Townscape and Visual Impact Addendum

DLR REFERENCE: PAC/LRD2/002/24

Date: 27th September 2024

APPENDIX A – CGI FROM GOATSTOWN ROAD TO THE NORTH (Viewpoint 6)

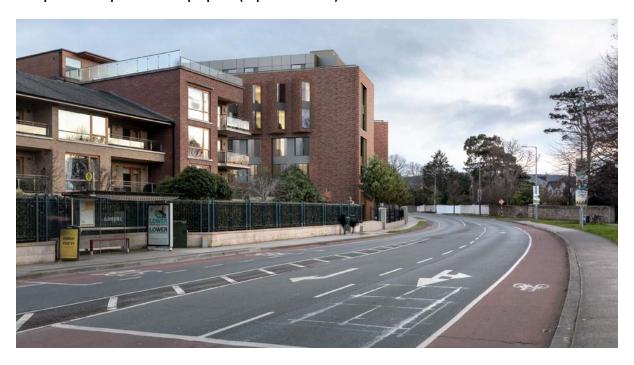
- 2.7 It is reasonable to suggest the amended layout does constitute an improvement particularly in relation to the set back of the northern elevation towards Trimbleston. This was originally six storeys but it has been reorientated to allow the sixth storey to be set back with angled windows and changes to the brick detail and pattern breaking up the façade providing it with more architectural interest. This has lessened any potential overbearing aspect of the building in this area. (Note that the nearest façade directly to the north within the Trimbleston development comprises a largely blank wall with no windows). See Appendix A
